MARK	DATE	DESCRIPTIONS	BY	CH'D	CCO#
2	01/31/07	CORROSION PROTECTION	JD	AS	16
1	07/21/06	W2 CAP BEAM ISD	JD	NV	23

SAN FRANCISCO OAKLAND BAY BRIDGE
EAST SPAN SEISMIC SAFETY PROJECT
SELF-ANCHORED SUSPENSION BRIDGE
(SUPERSTRUCTURE & TOWER)

W2 CAP BEAM POST-TENSIONING DETAILS NO. 1

FILE => I:\bb\04-012001\sas\contract plans and cco\cco\in progress\cco#16\aecpt01.dgn

TOP TENDON LAYOUT PLAN ("E" Line)

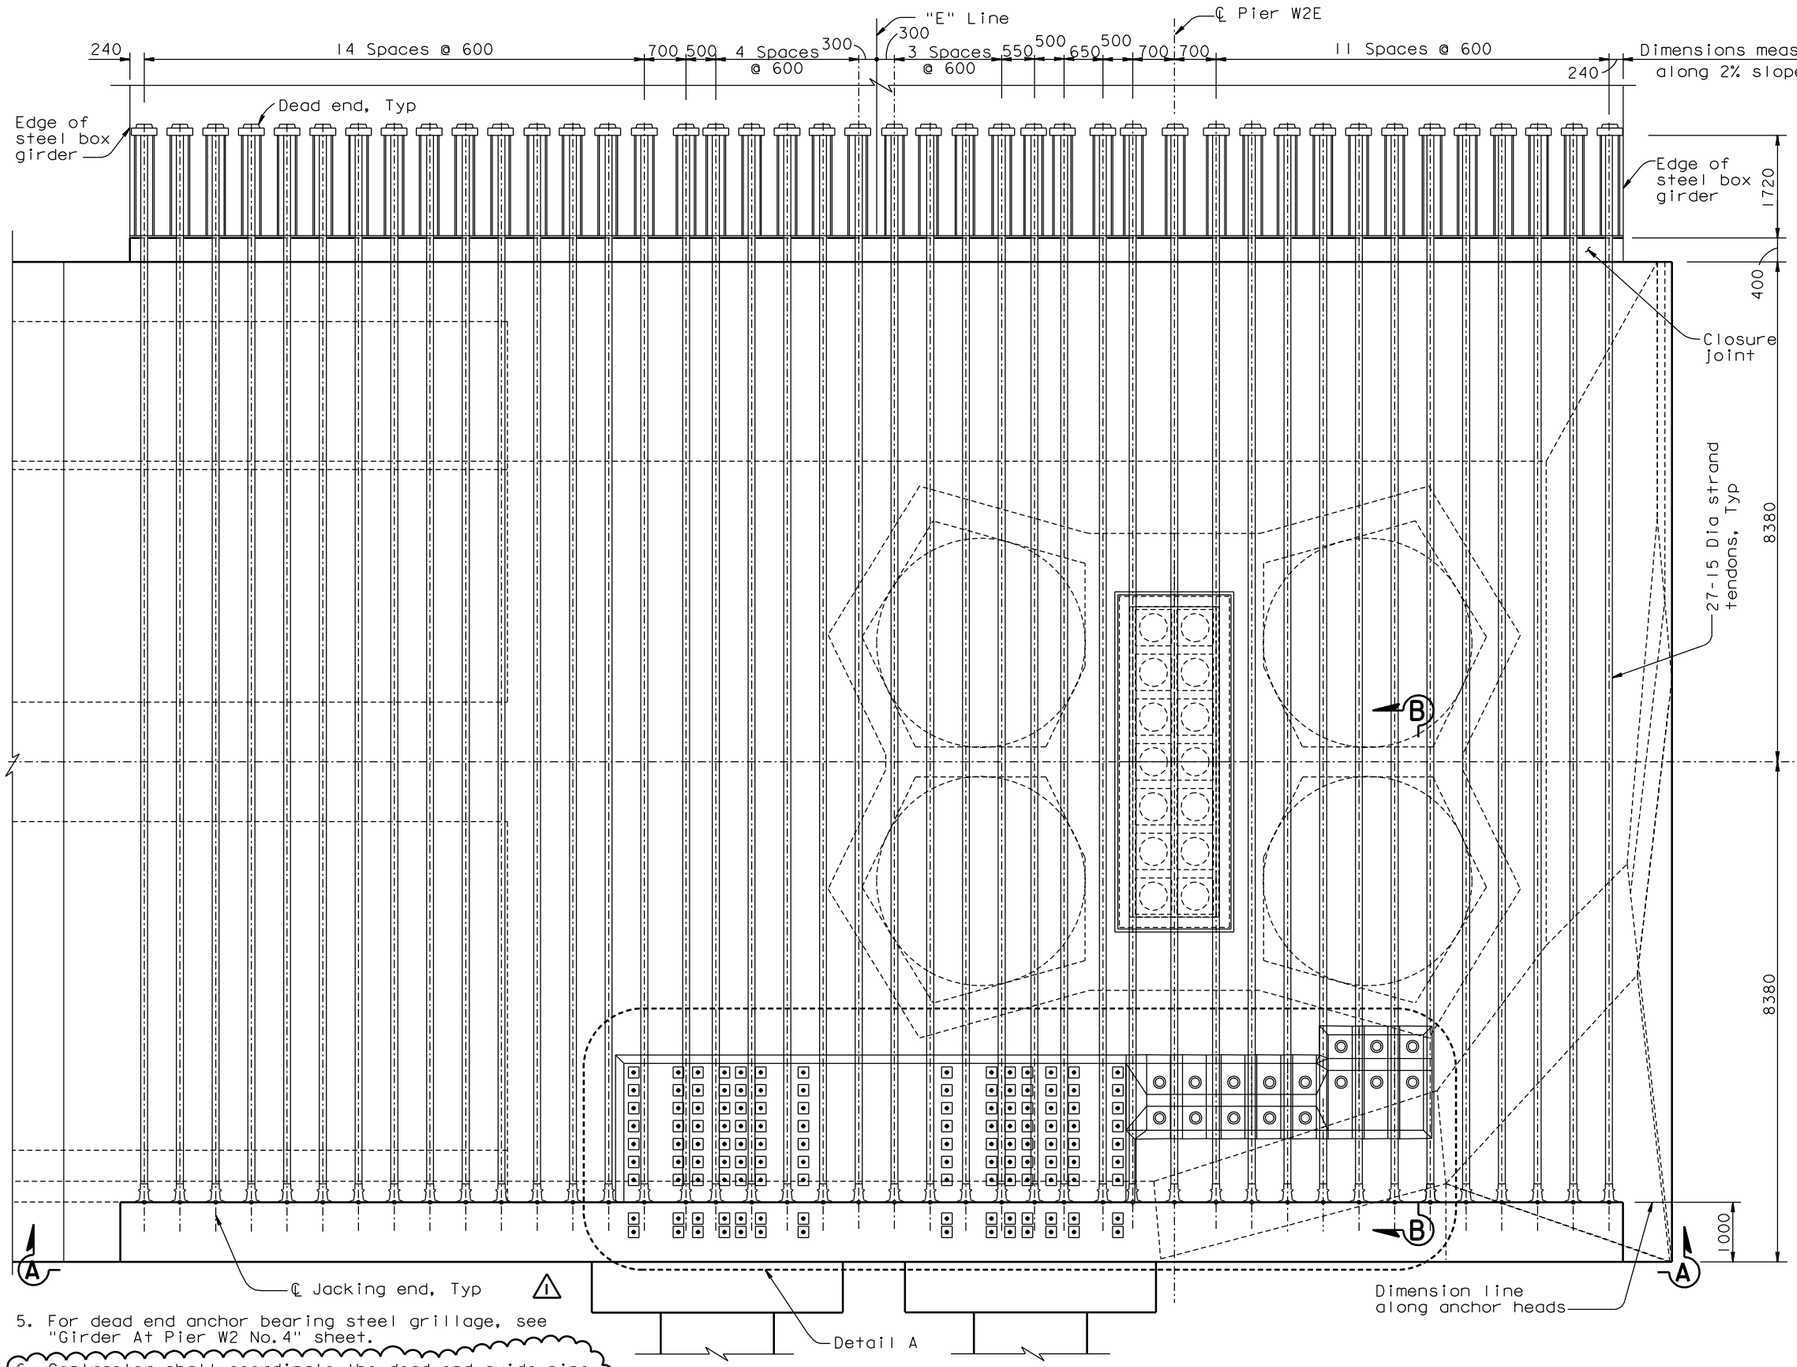
6. Contractor shall coordinate the dead end guide pipe details with the PT System Supplier and shall submit them to the Engineer for review and approval. Contractor shall grout the guide pipe after stressing operations have been completed. (2)

△1 **PLAN-TENDON TYPE 9**

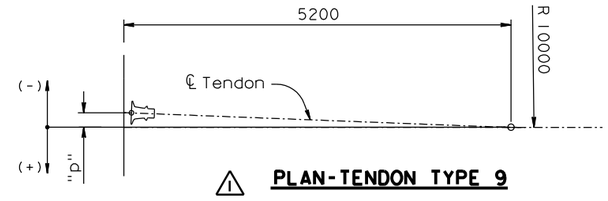
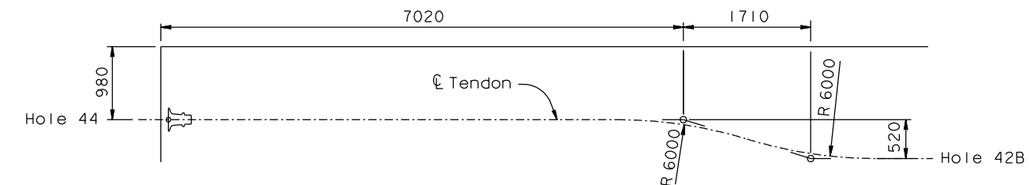
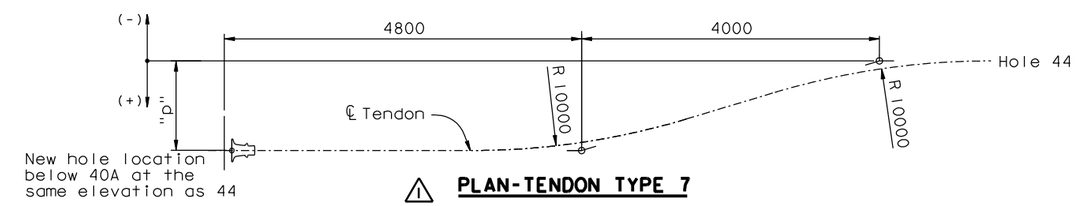
△1 **ELEVATION-TENDON TYPE 10**

△1 **ELEVATION-TENDON TYPE 6**

△1 **PLAN-TENDON TYPE 7**

△1 **PLAN-TENDON TYPE 8**

2 DEAD END GUIDE PIPE
NTS (see Note 6)

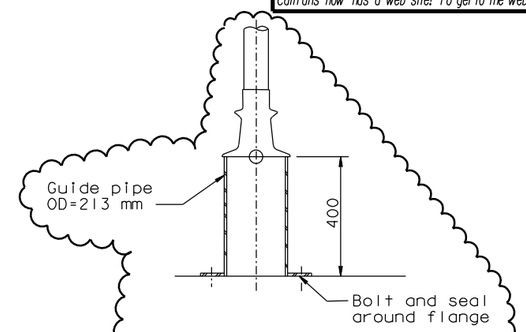
1. Cap beam reinforcement not shown for clarity.
2. Local confining spiral reinforcement for tendon anchors shall be provided by PT tendon hardware supplier.
3. Blockouts on the cap beam "E" Line shown, blockouts on the cap beam "W" Line similar.
4. (1) For Details A and C, see "W2 Cap Beam Blockout Details No.12" sheet.
5. For additional prestressing details, see "Prestressing Notes" sheet.
6. (2) Contractor shall coordinate the dead end guide pipe details with the PT Supplier and shall submit them to the Engineer for review and approval. Contractor shall grout the guide pipe after stressing operations have been completed.
